DIVISION OF PURCHASES BID NO. 7549238

RHODE ISLAND CONTRACT NO.2015-CT-043

**Enhanced Roadside and Recessed Freeway Delineation (Older Drivers Special Rule) (164HE)**

ADDENDUM NO. 1 Prospective bidders and all concerned are hereby notified of the following changes in the Plans, Specifications, Proposal and Distribution of Quantities for this contract. These changes shall be incorporated in the Plans, Specifications, Proposal and Distribution of Quantities, and shall become an integral part of the Contract Documents.

DRAWING No. **D-7**  
 SHEET No. **7** OF **37**

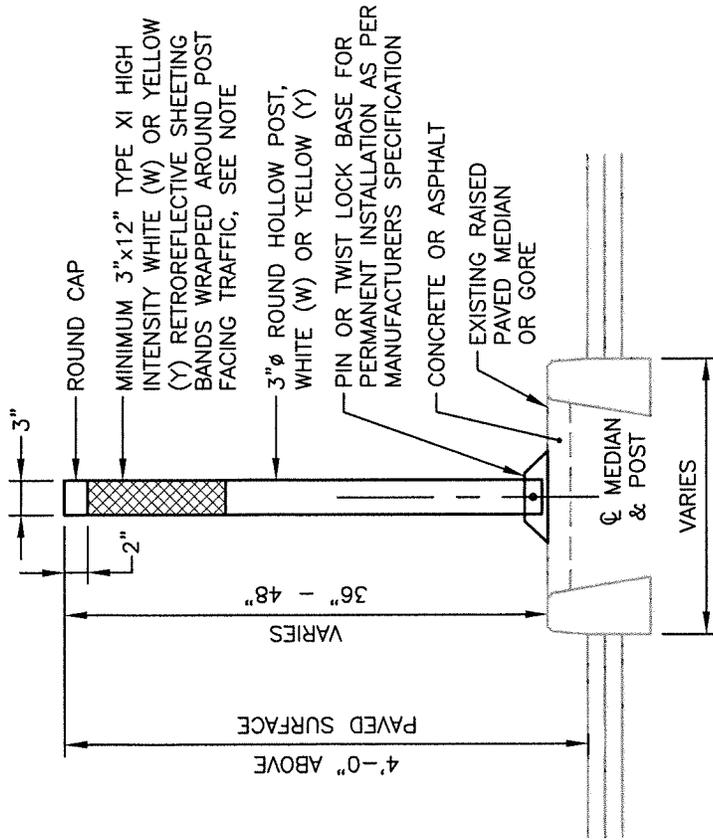
1. Appendix A – Cover Sheet  
Delete the Cover Sheet in its entirety and replace with the attached Cover Sheet. The Cover Sheet has been signed.
2. Appendix B – Transportation Management Plan  
Delete Page 3 in its entirety and replace with attached Page 3(R-1). The Transportation Management Plan has been signed.
3. Drawing D-7 (Appendix C)  
Delete Drawing D-7 in its entirety and replace with attached Drawing D-7(R-1). Note 1 has been revised.

1. SURFACE MOUNTED FLEXIBLE DELINEATORS SHALL BE WHITE WITH WHITE RETRO-REFLECTIVE SHEETING OR YELLOW WITH YELLOW RETRO-REFLECTIVE SHEETING, PLACED ONLY ON SOUND PAVEMENT AND BOLTED OR EPOXIED INTO PLACE, PERFORMED PER MANUFACTURER'S RECOMMENDATIONS. PRIOR TO INSTALLATION, THE CONTRACTOR SHALL COORDINATE WITH THE ENGINEER TO ENSURE THE PAVEMENT CONDITION IS SATISFACTORY FOR THE INSTALLATION OF SURFACE MOUNTED DELINEATOR, OTHERWISE, THE DELINEATORS MAY BE OMITTED
2. SHOULD DELINEATOR BECOME DISLODGED FOLLOWING INSTALLATION, CONTRACTOR WILL BE REQUIRED TO RESET AT NO COST TO THE STATE.
3. CONCRETE SURFACES SHALL BE WIRE BRUSHED OR SAND BLASTED, AND TREATED ACCORDING TO THE MANUFACTURER'S RECOMMENDATIONS PRIOR TO INSTALLATION OF DELINEATOR.
